August 21, 2020  
Project No. 200055.2

Subject: Response to City of San Diego LDR-Geology  
Environmental Review  
City Project No. 630996; Cycle 5

Project: City of San Diego Task 15GT15 – Water and Storm Drain Group 968  
San Diego, California

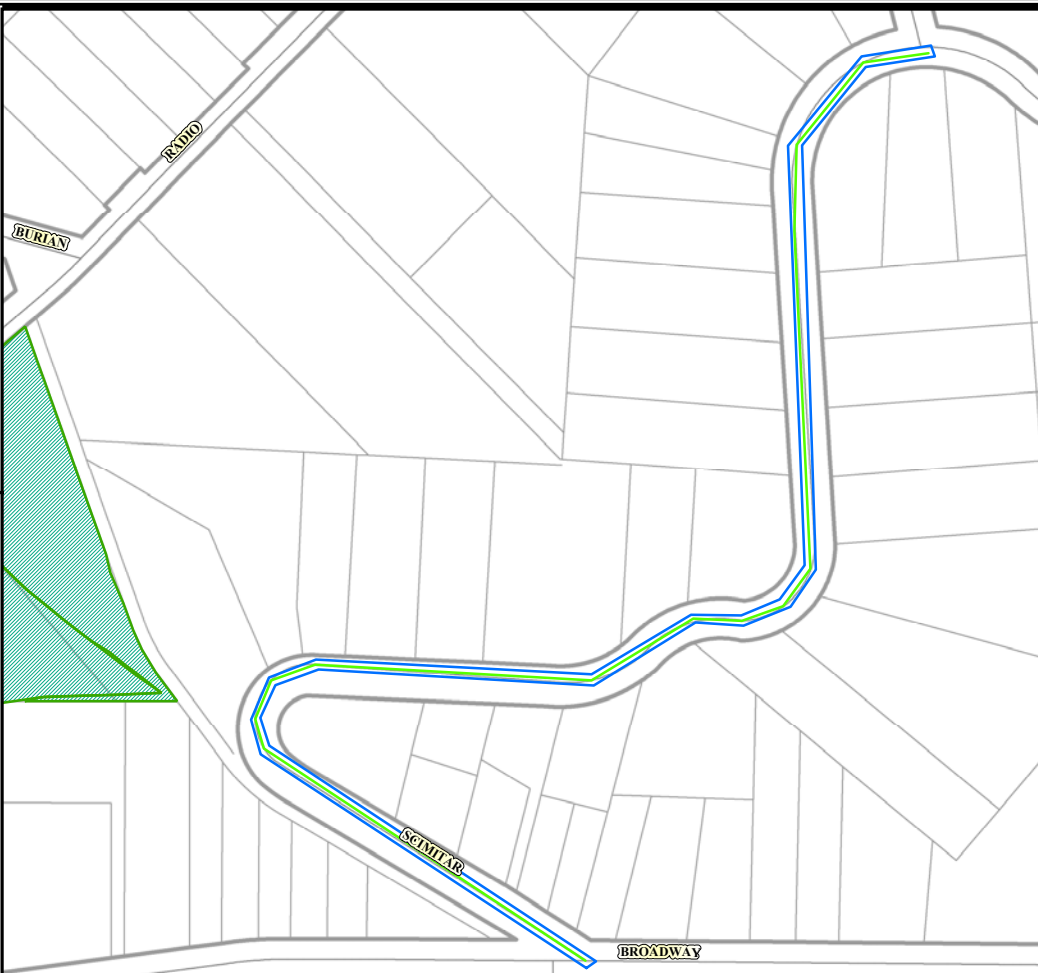
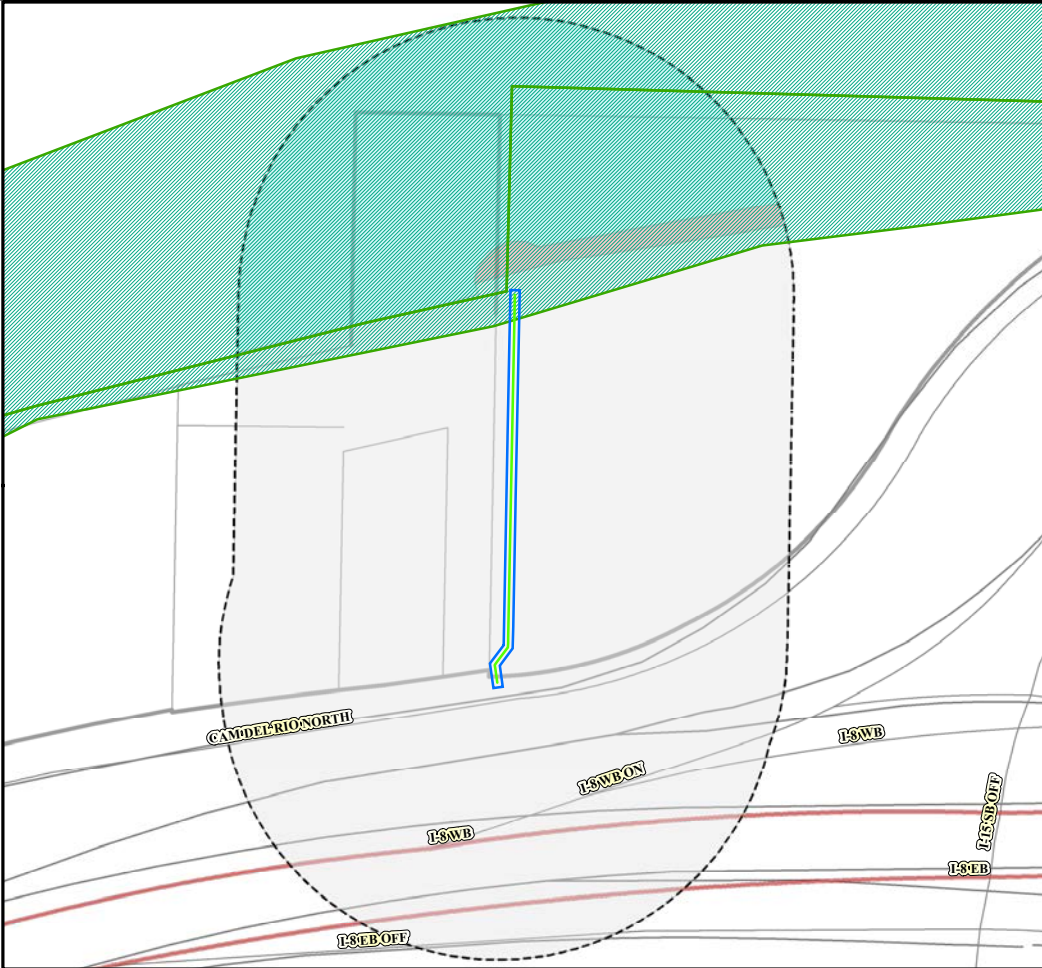
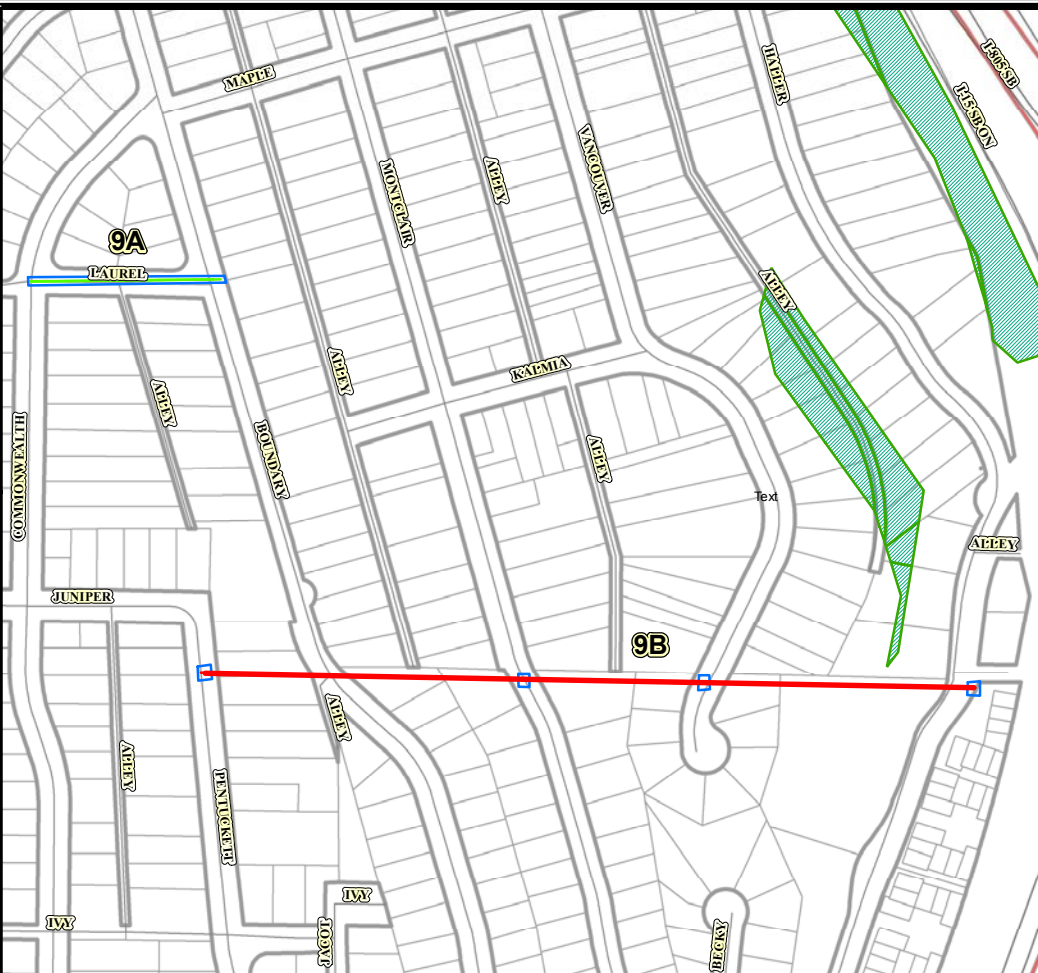
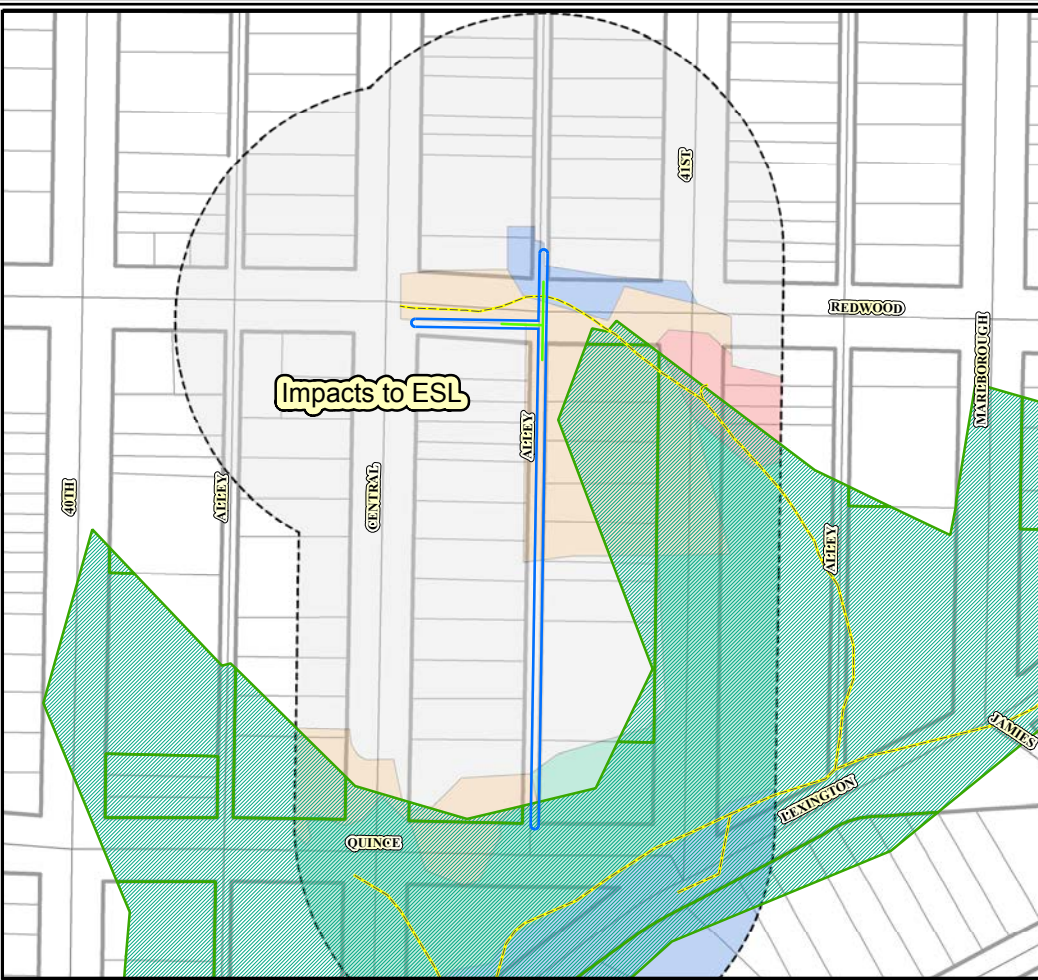
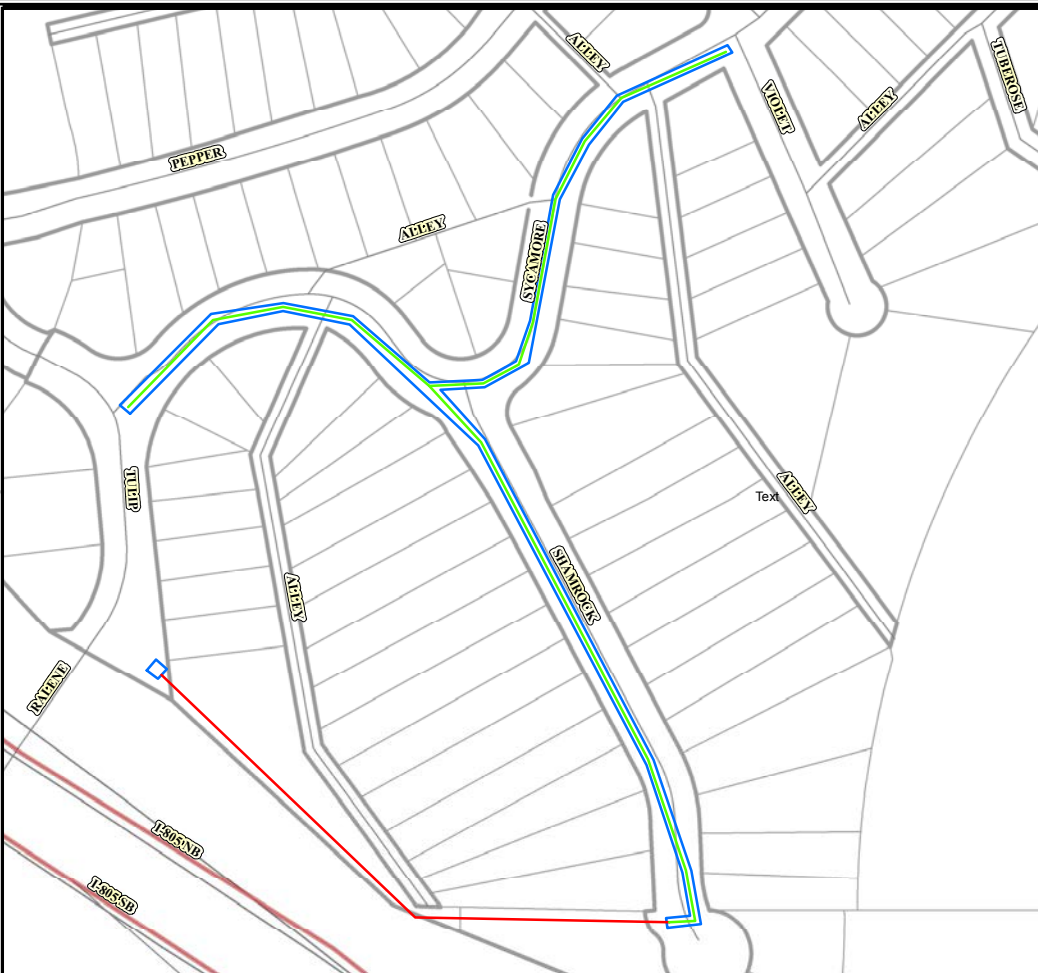
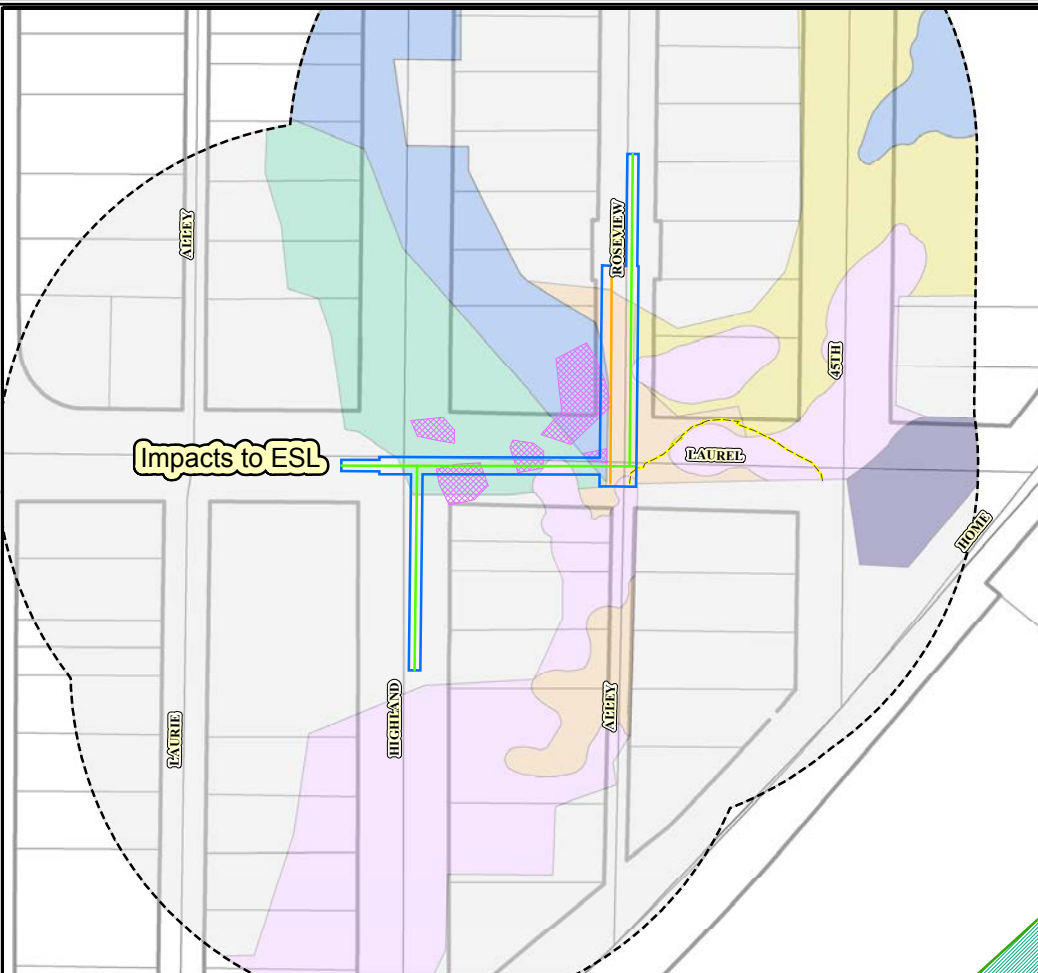
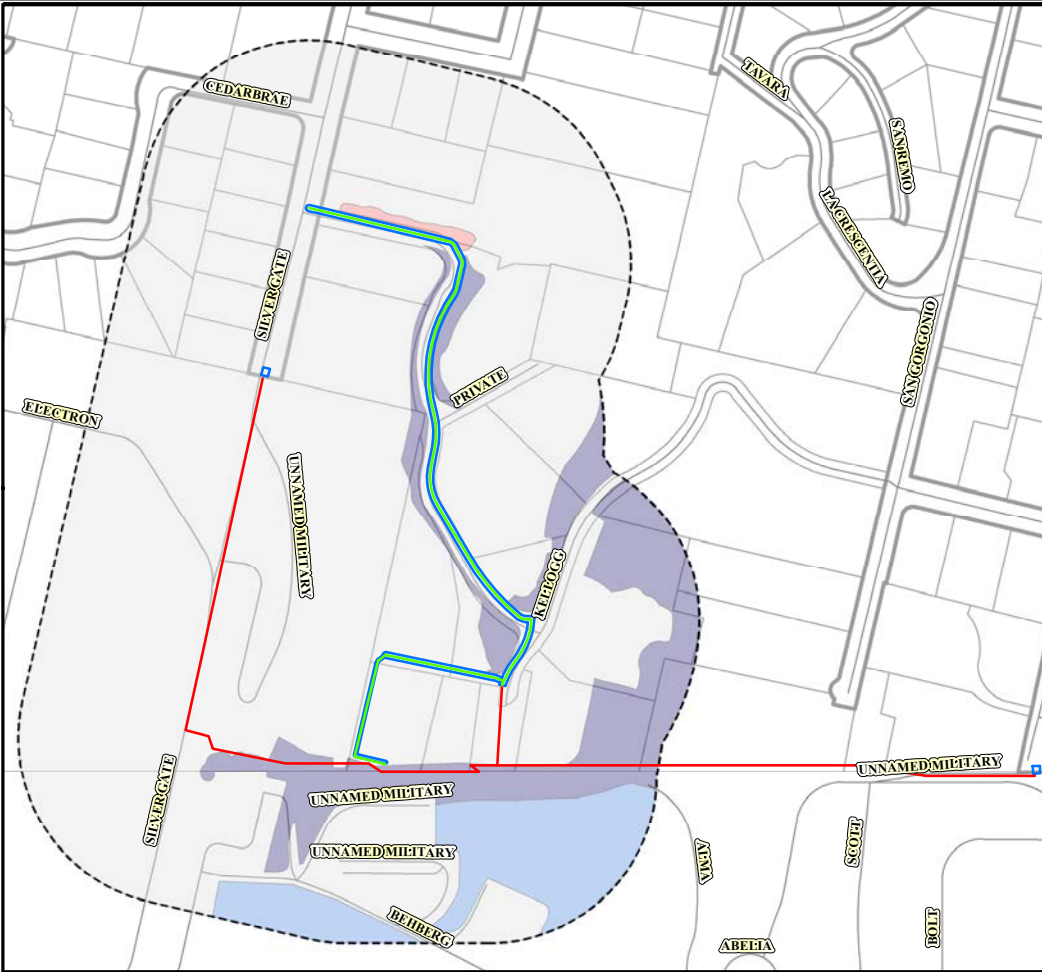
**City Cycle 5; Issue No. 8:** **The geotechnical investigation report should contain a geologic/geotechnical map in areas of proposed construction within environmentally sensitive land. The limits of anticipated remedial grading should be circumscribed to delineate the proposed footprint of the project in these areas.**

**Twining Response:** *Twining has reviewed the City of San Diego ESL maps and proposed limits of work as shown for each site on Figures 1 through 10. Twining confirms that geotechnical remedial grading should not be necessary outside these areas. The geologic maps of areas of proposed construction were previously presented in the referenced Twining reports (References iv and vii). [Please note that Figures 3 & 7 include 2018 biological limits for proposed limits of work; however, based on the updated 2020 construction plans, there will be no water main built in some of those areas. In addition, Twining does not determine ESL for biological resources, and the City has stated that steep hillsides (ESL Steep Slopes) are not a CEQA issue for pipelines].*
